Access Compliance Report Public Rights-of-Way (Curb Ramps)

Main Street: ISLAND_WAY	Cross Street: ISLAND_WAY	Location: W
-------------------------	--------------------------	-------------

ADA ID: RPRK220221172234	Ramp Type: Type 4 - Parallel	Initial Pass/Fail: Pass	Overall Compliance: No	Severity Score: 5
--------------------------	------------------------------	-------------------------	------------------------	-------------------

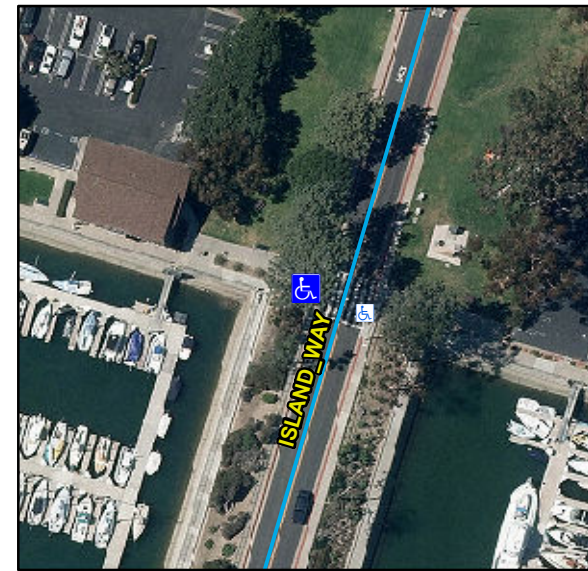
Yes	Ramp Inside Crosswalk 1	Yes	N/A	Ramp Inside Crosswalk 2	N/A
	Crossing 1 Slope (%)	0.9		Crossing 2 Slope (%)	N/A
	Crossing 1 Cross Slope (%)	0.3		Crossing 2 Cross Slope (%)	N/A
Yes	Gutter Ponding	No	Yes	Curb Slope	4.6
Yes	Gutter Lip Height (in)	0		Road Run Slope (%)	N/A
No	Gutter Run Slope (%)	5.5		Road Cross Slope (%)	N/A
Yes	Gutter Cross Slope (%)	0.7	Yes	Perpendicular Joint Present	Yes
Yes	Overall Surface Condition	Acceptable			
	Cross Gutter Present?	No		Spandrel Present?	No
	Replace Cross Gutter?	N/A		Replace Spandrel?	N/A

Remove & Replace Gutter.

R304.5.4, STD 1115
